City of Doral
ITB 2025-21
Doral Meadow Park Playground Renovation
Addendum No. 5

September 30, 2025

Project: 215618515
Date: September 29, 2025
Issued By: Mark Beer

Re: Doral Meadow Park Playground Improvements - Addendum 05

SITE MATERIALS PLAN		
Project No.	Scale	
215618515 / 23P005	1" = 10'	
Drawing No.	Sheet	Revision
	L111

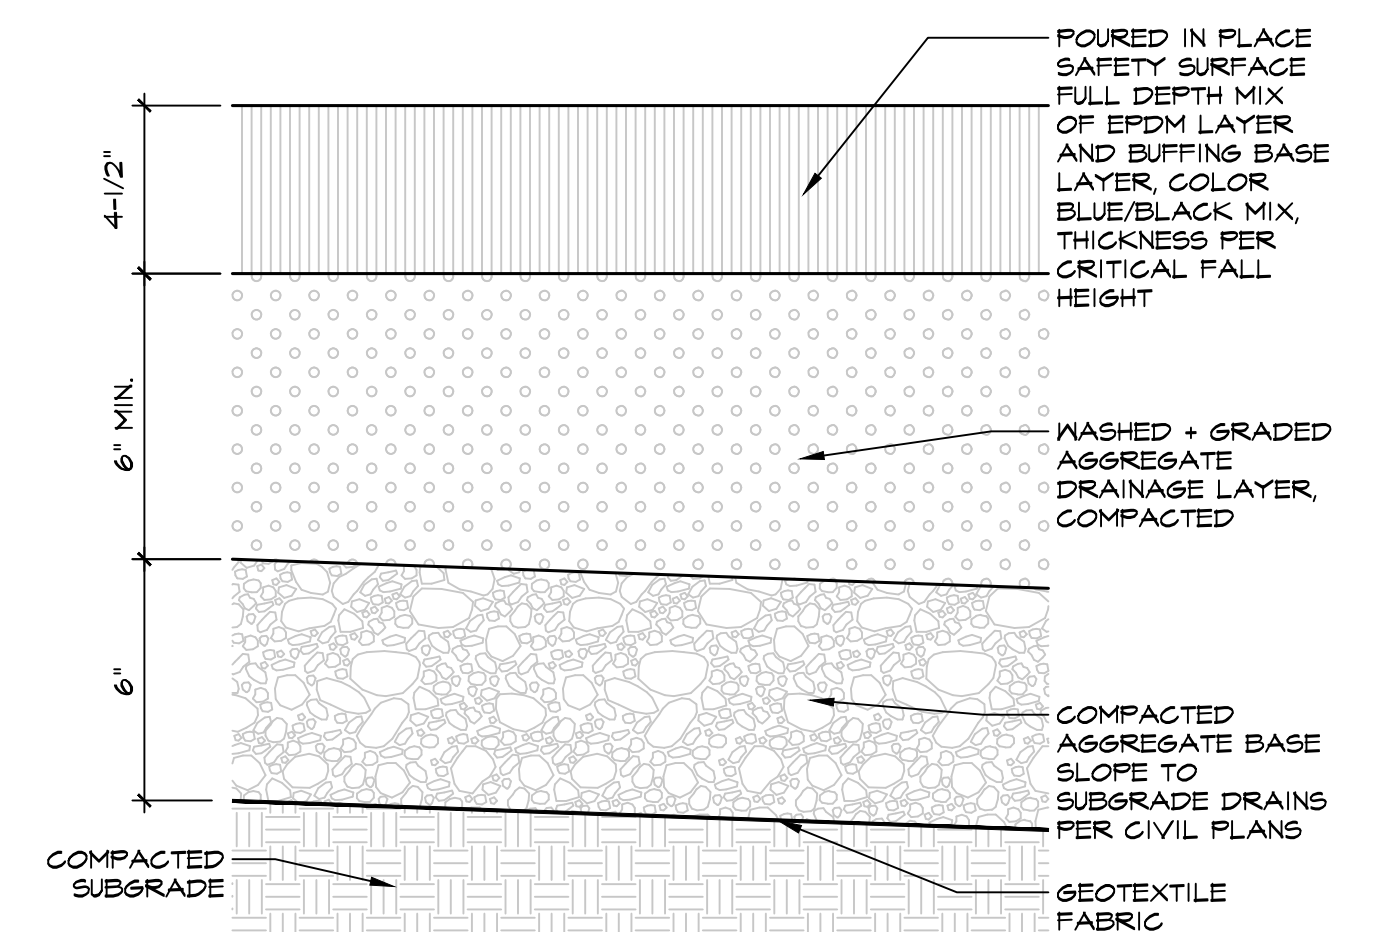
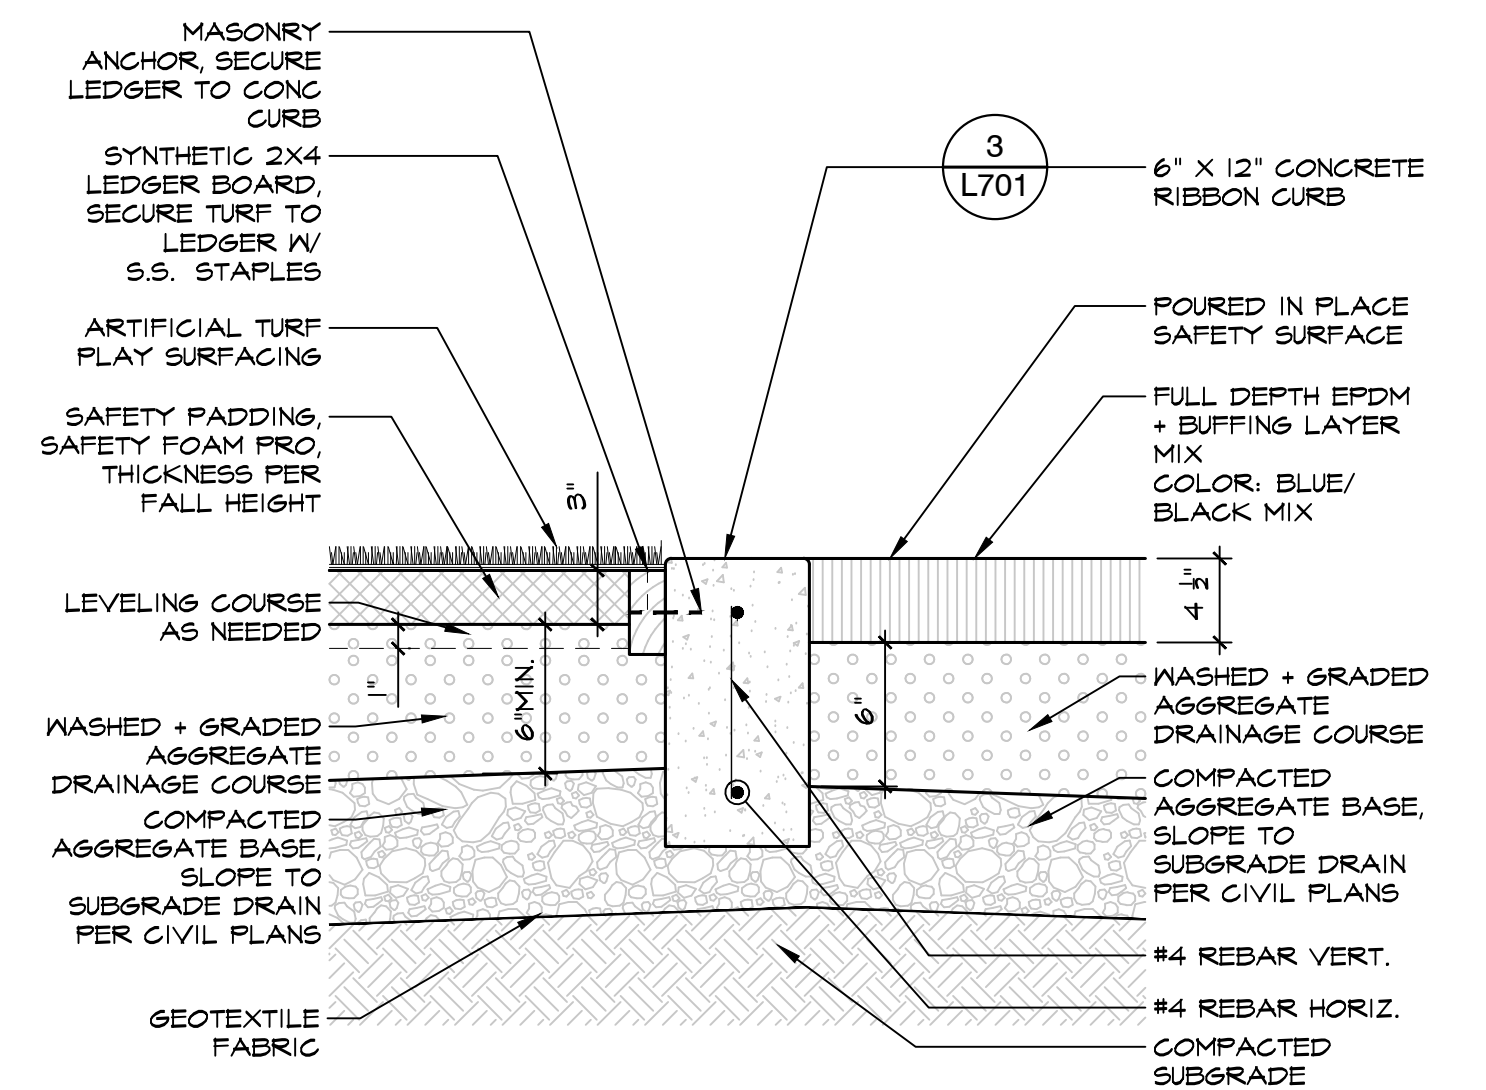
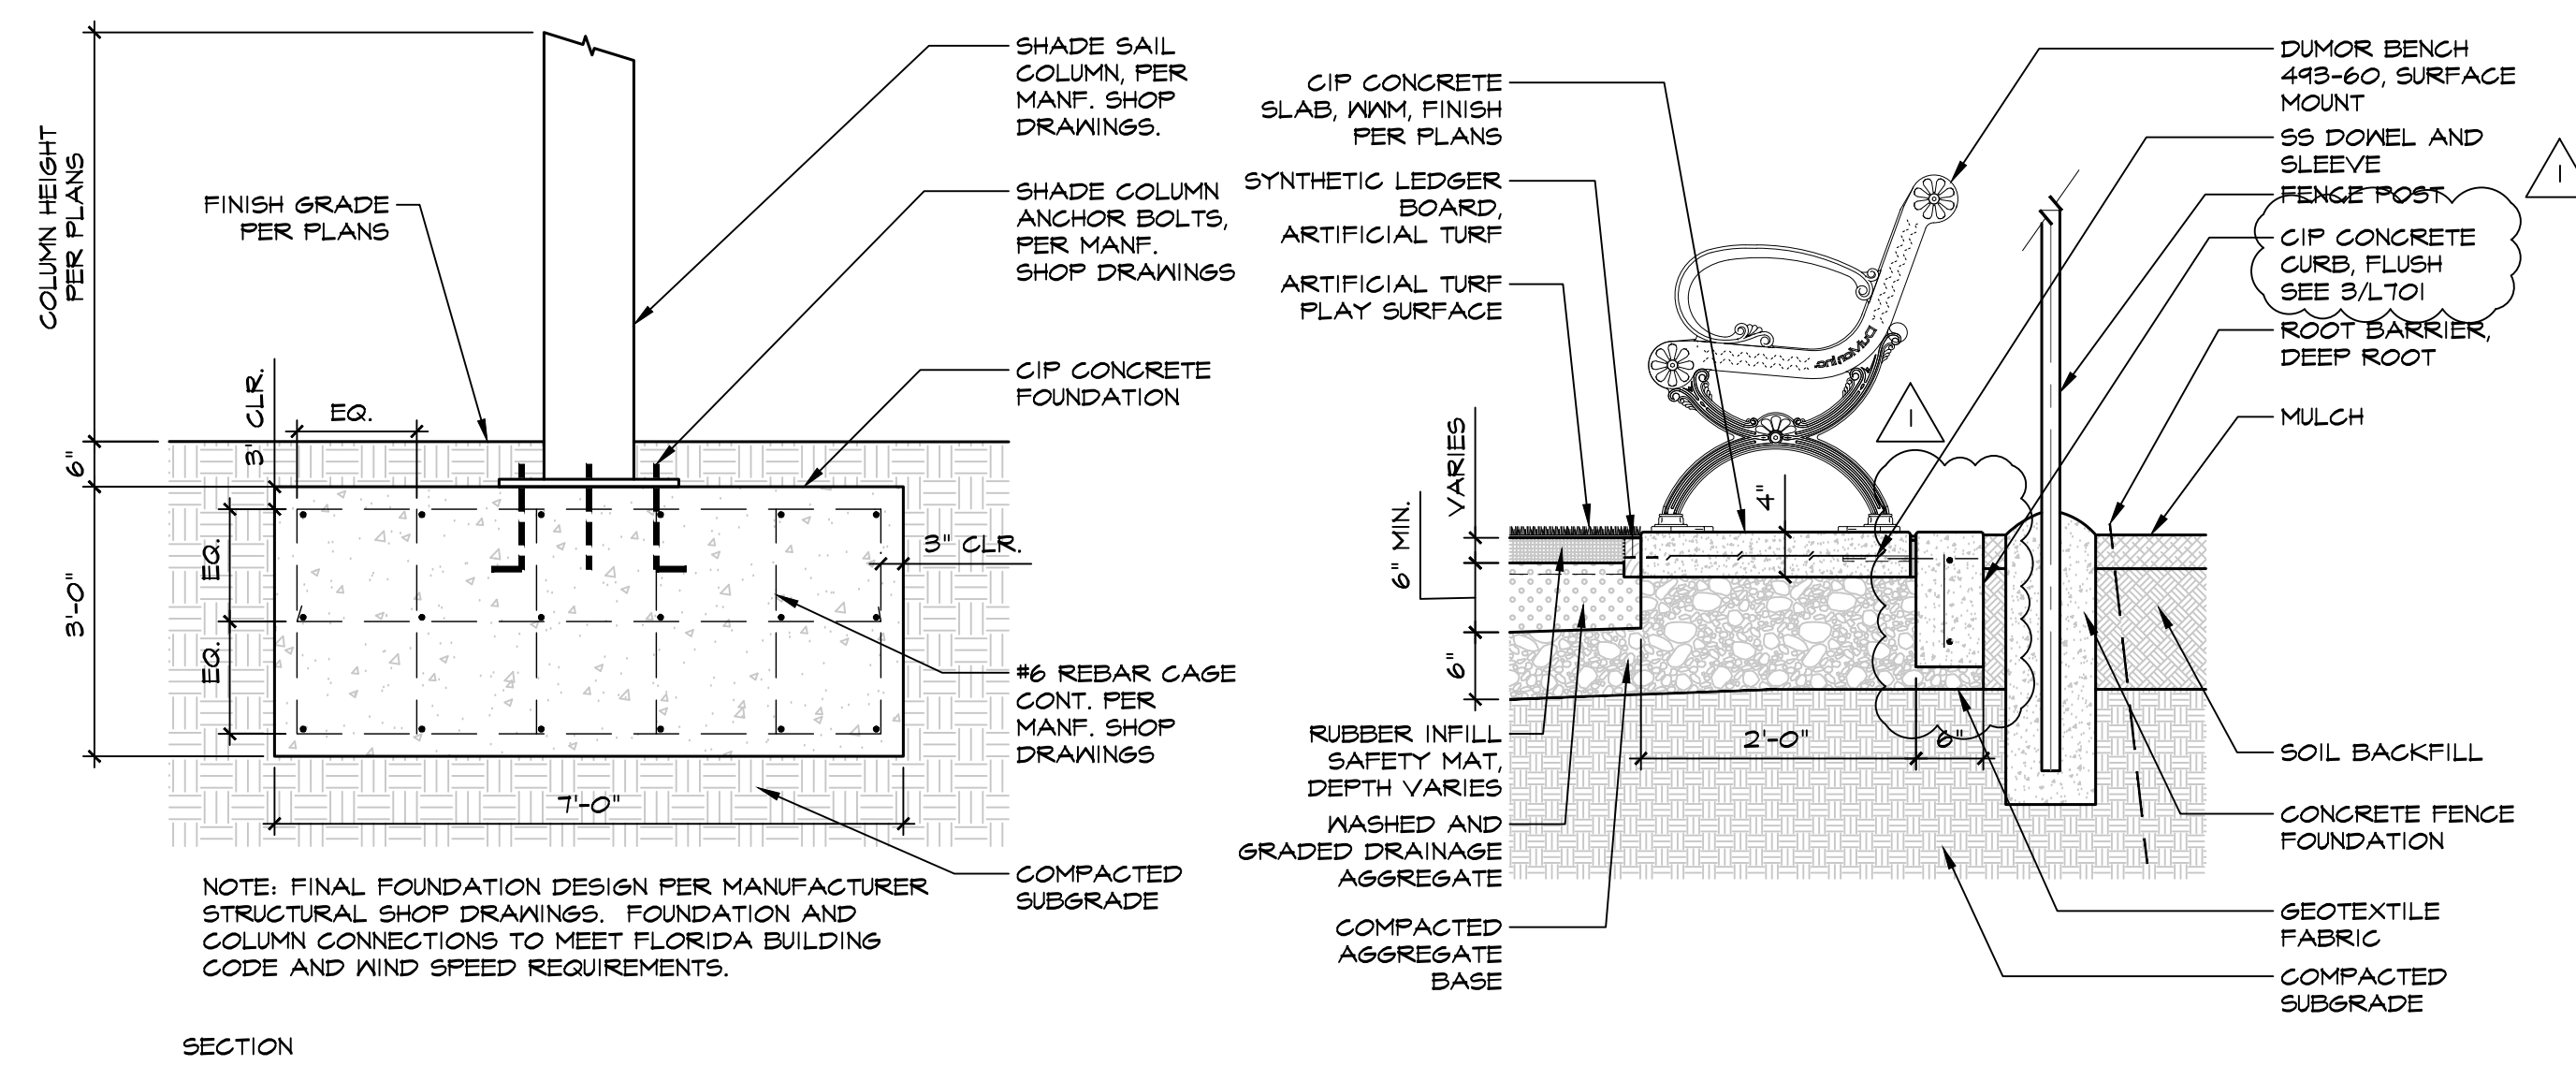
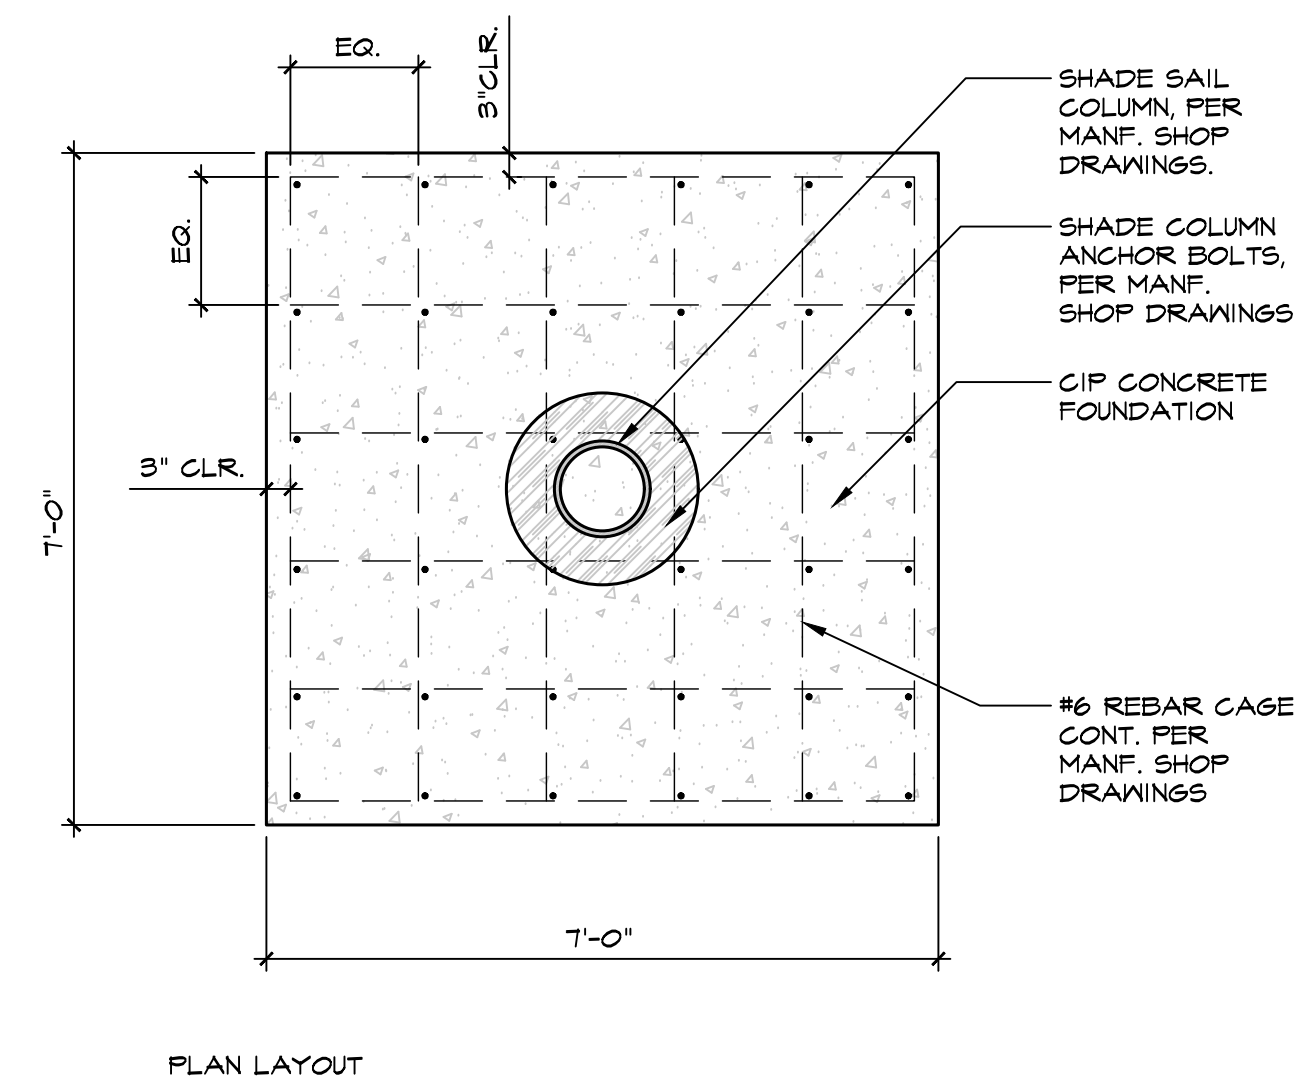
2. Q. Sheet L111 specifies 6' wide double swing gates with self-closing hinges. Double swing gates cannot be installed with self-closing hinges unless it has a center latch post. Specify whether the gates should have standard hinges without a center post, or if they should have self-closing hinges with a center latch post.

- L111 – Site Materials Plan (sheet reissued)
 - Reference Note G-01 updated to read:
 - Gate – Single Swing, Chain Link, Black Vinyl Coated, Self Closing, Magnalatch or similar hardware. 4'-0" clear, ADA accessible.
 - Reference Note G-02 struck from reference schedule
 - Reference Note MS-07 added to reference schedule
 - Existing water fountain to remain
 - Drawing revised to show single swing gates at all entry points
- L701 – Site Details (sheet reissued)
 - Detail 04 updated
 - Fabric gauge revised to 9 gauge
 - Dimension, height of fence revised to 4'-0"
 - Dimension, post spacing, revised 6'-0" typ.
 - Terminal Post OD updated
 - Notation for concrete footers revised
- L702 – Site Details (sheet reissued)
 - Detail 03 updated
 - Concrete curb updated to reflect ribbon curb in detail 02/L702 and standard detail 03/L701.
 - Notation for curb updated
 -

A. Gates have been revised to all be single swing gates with self-closing latch, 48" single swing, self-closing gate hinges. See L111 for updated notes.
